ACT Urban Water Quality Management Infrastructure:
Asset Report

May 2016

Asset 1A: Crace Bioretention Basin - Medhurst Crescent

Figure 6: Summary of rectification works required to wall

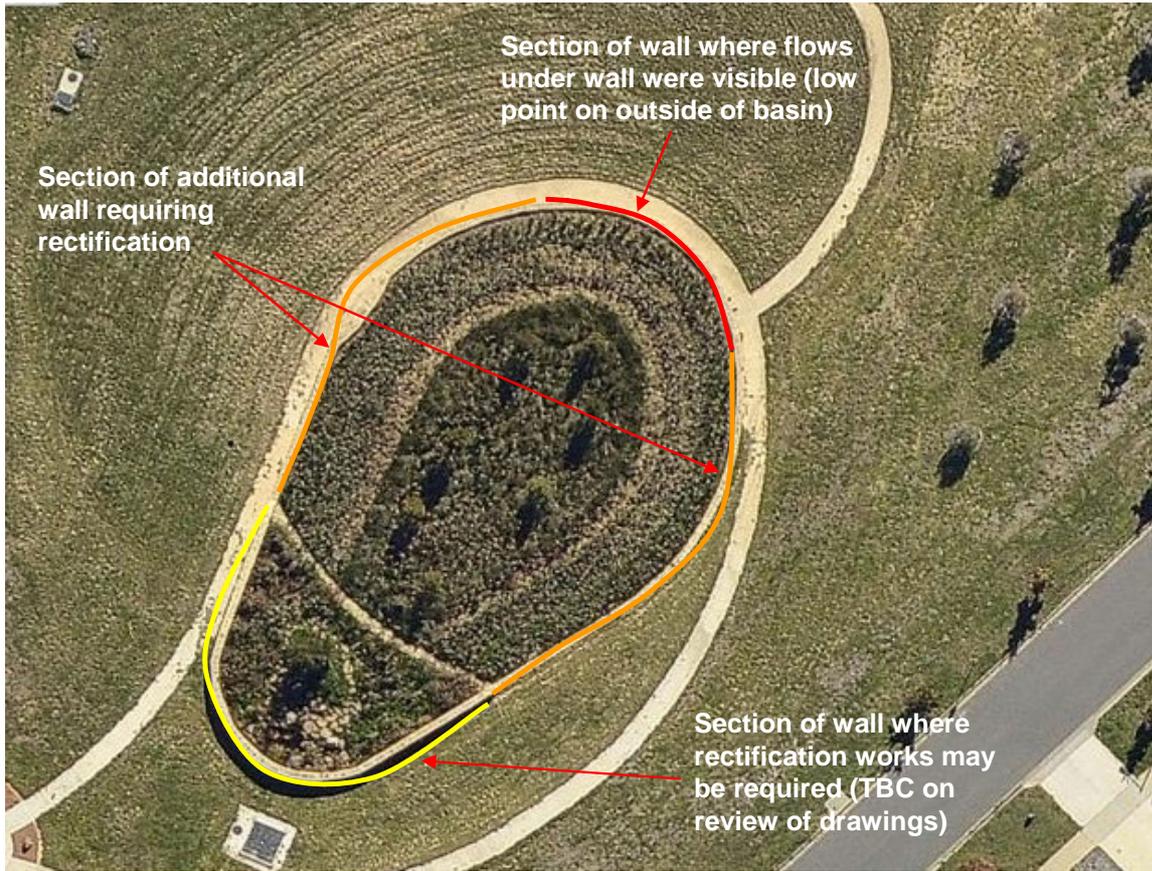
A key constraint in repairing the flows under the wall is the potential for leakage under the entire length of the wall, and therefore a rebuild of the entire wall is likely to be required. Currently the wall is visibly draining out at the lowest point behind the wall. If, for example, only the northern section of the wall was addressed it is highly likely that water would flow out under the wall at the next lowest point. A summary of the works required to the wall is shown in Figure 6.

Another key constraint in rectification works is that to repair the wall the filter media in the basin would need to be removed for two to three metres adjacent to the wall around the entire edge around the basin. The basin filter media could be carefully stored and replaced.

It is recommended to undertake rectification works to the wall to prevent water flowing under the wall. The exact measures to rectify this issue need to be confirmed once the existing design drawings are reviewed and an informed review of the current defect can be determined. However we expect that external patching of the wall is unlikely to be effective and that rectification will require some sort of lining system to the internal portion of the wall to prevent water flowing under the wall, or some rectification works to the wall itself and its sub-grade to prevent water flowing under the wall. Other options could also be considered once the details of the wall are known.

Figure 1: Recirculation flow path: intended vs actual flow path

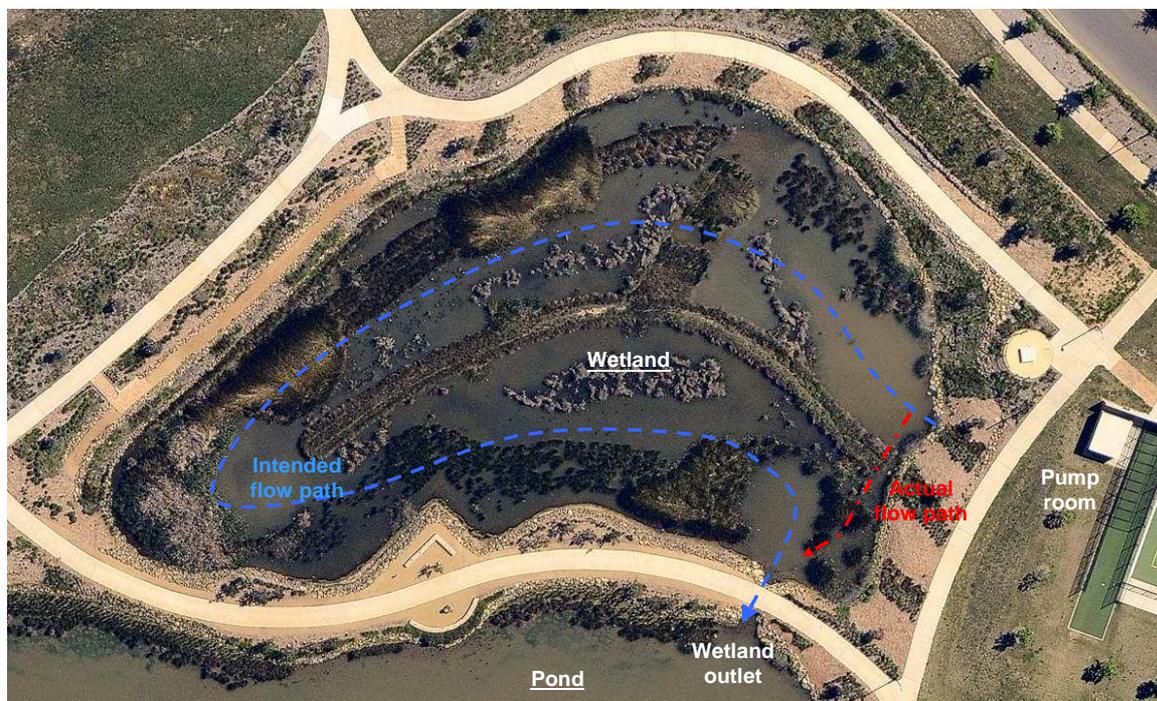
- The flow path through the wetland is seriously compromised. The intended flow path is for water to be directed through the entire vegetated component of the wetland. This is shown in Figure 1 via the blue dashed line flow path. However the central embankment does not extend all the way to the eastern edge and hence flows actually completely bypass the wetland vegetation (as shown by the actual flow path by the red line in Figure 1).

- To be effective, the wetland cell needs to be entirely planted across the wetland. As can be seen in Figure 1 and Figure 2 there are large areas of the wetland which are un-vegetated. The red line in Figure 2 shows how the flows are bypassing the wetland vegetation and significantly reducing the treatment that the recirculation flows are achieving in the wetland. A review of aerial imagery in Nearmap shows that this area of vegetation has not been successfully established at any time. This suggests that rather than the planting being established properly and then dying back the wetland plants have never been properly established. It is likely that either the vegetation failed almost immediately after planting or the wetland cell was not actually entirely planted as per the planting plan - as the planting plans for the wetland shows that these areas were intended to be fully vegetated.

1. Rectify the embankment works in the wetland to prevent the short circuiting of the system
2. Re-establish vegetation in the wetland throughout the entire macrophyte cell (further investigations into the failure mechanism of the vegetation is recommended prior to this being undertaken)

Figure 4: Pond outlet operating during wet weather event

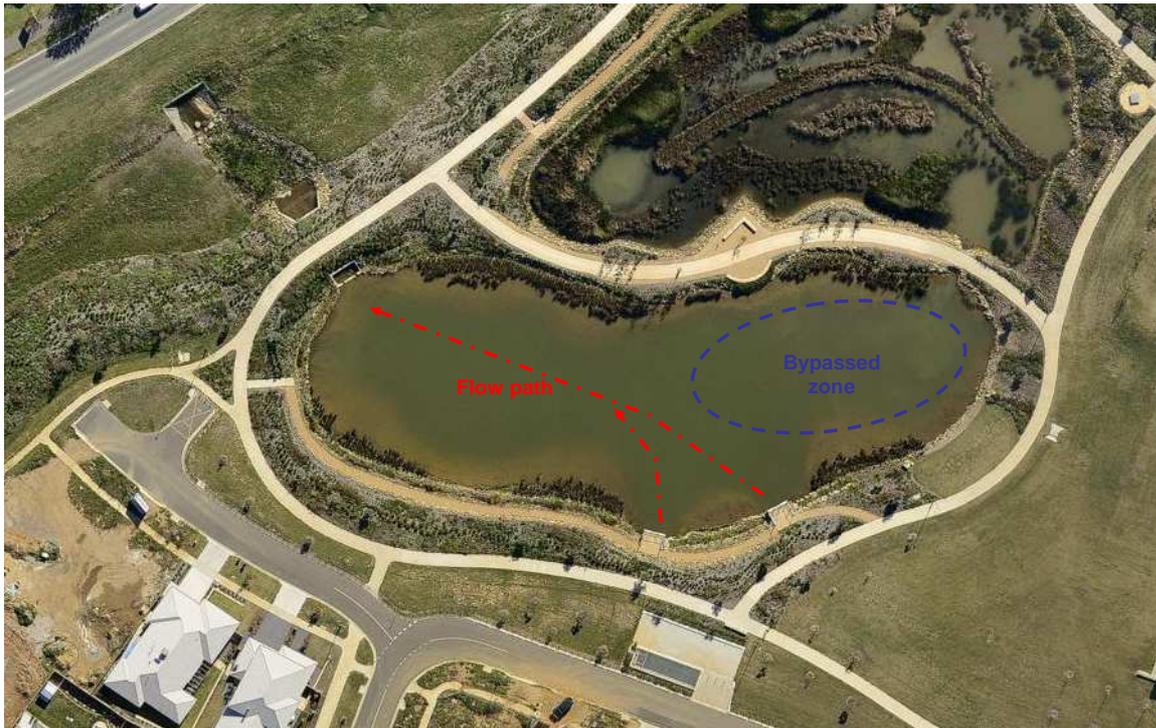
- The outlet was observed during wet weather events to be operating effectively and was hydraulically stable with no signs of erosion, scour or similar, as shown in Figure 5
